MIPS R4400PC/SC Errata, Processor Revision 1.0

February 9, 1994

Figure 1a: Power-on Reset or Cold Reset - Workaround for Bug# 22

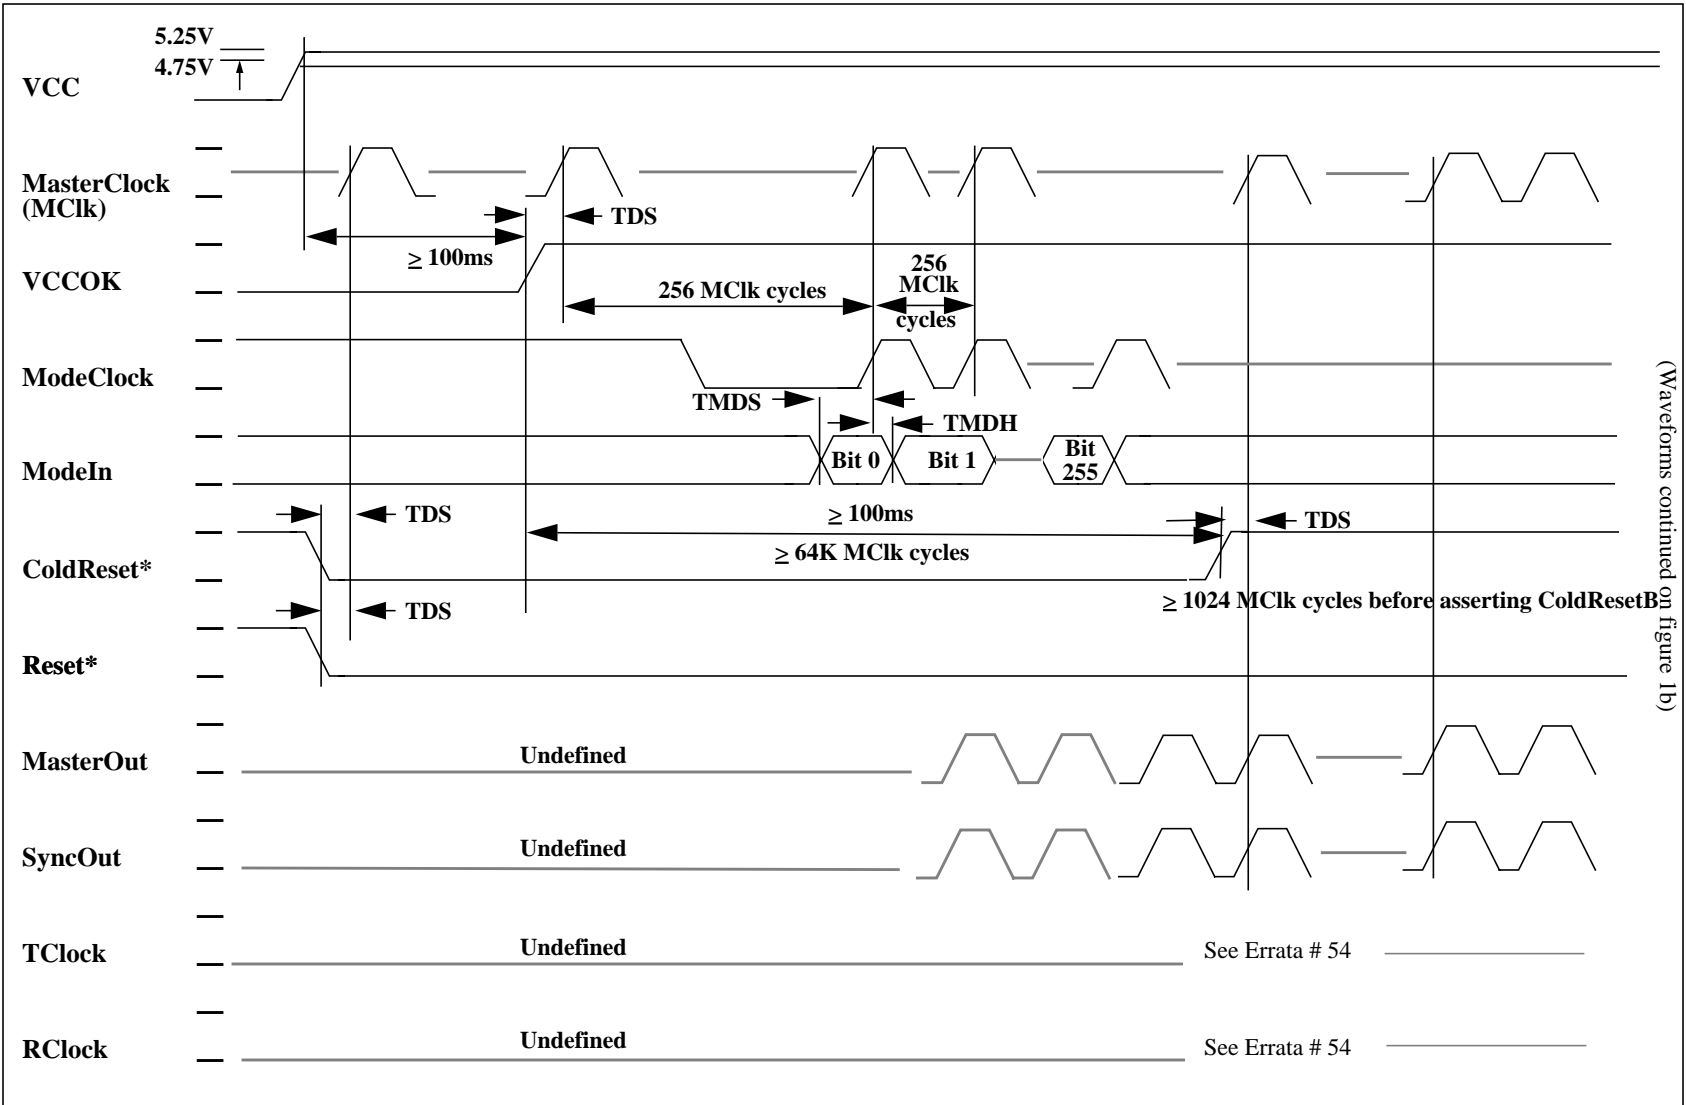
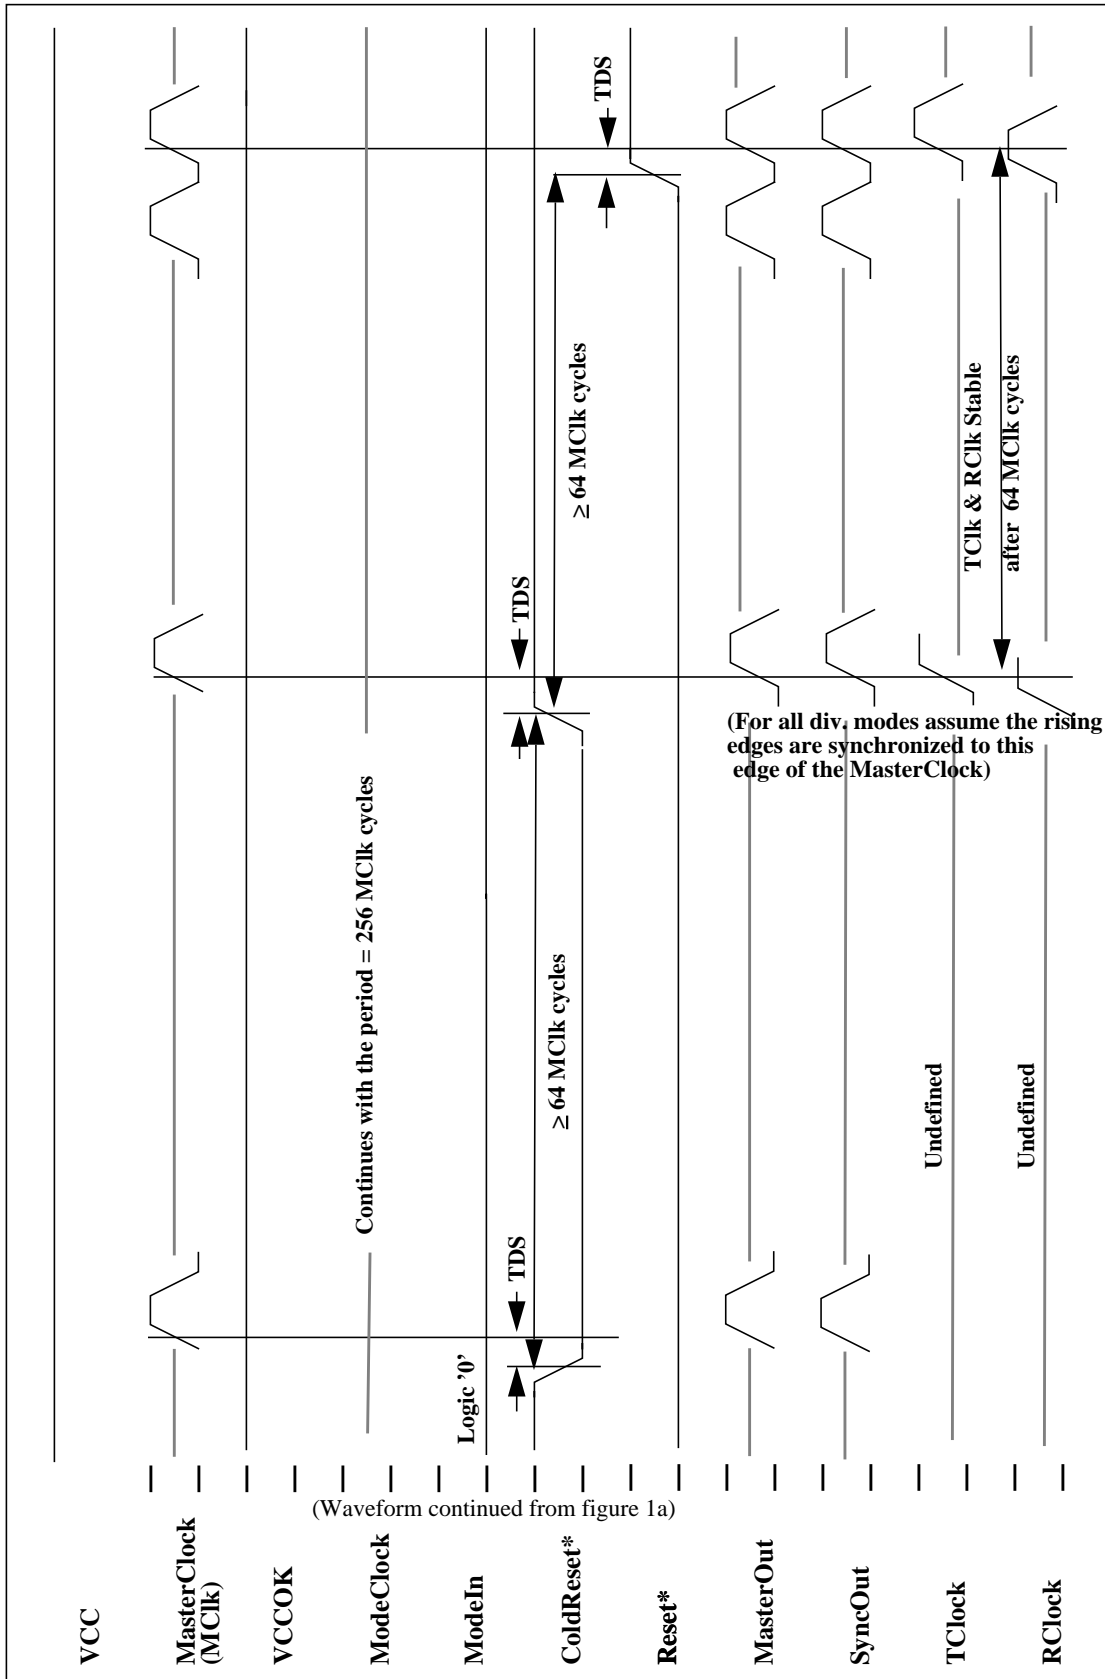
- 22. R4400PC, R4400SC: During the power up sequence, the period of TClk and RClk may not be as expected for at least 1024 MasterClock cycles following the de-assertion of ColdResetB. The above bug is true for all system interface divisors. Furthermore, if the system interface divisor other than 2 (i.e. 3,4,6 & 8) is used, TClk and RClk's rising edge may not align to the rising edge of the MasterClock, as specified.

This may not be a problem for systems using only TClk for the external logic. However, certain systems like -

- 1) systems using MasterClock for the external logic
- 2) system with external PLL which needs to lock with the internal PLL
- 3) systems with multiple processors operating in lock-step

this bug may cause problems.

Thus, for system with interface divisor set to two, the only violation will be that the TClk and RClk's period might not be valid within 64 MasterClock after the ColdResetB is de-asserted.

Workaround: Assert a second ColdResetB after at least 1024 MasterClock cycles from the de-assertion of the first ColdResetB. ResetB should remain asserted until at least 64 MasterClock cycles following the de-assertion of the second ColdResetB. TClk and RClk will then be valid 64 MasterClock cycles after the de-assertion of the second ColdResetB and their edge alignment with respect to MasterClock will be as specified. Figure 1a & 1b show the waveforms in more detail. Note that the waveforms in Figure 1b are continuation of the those in figure 1a.
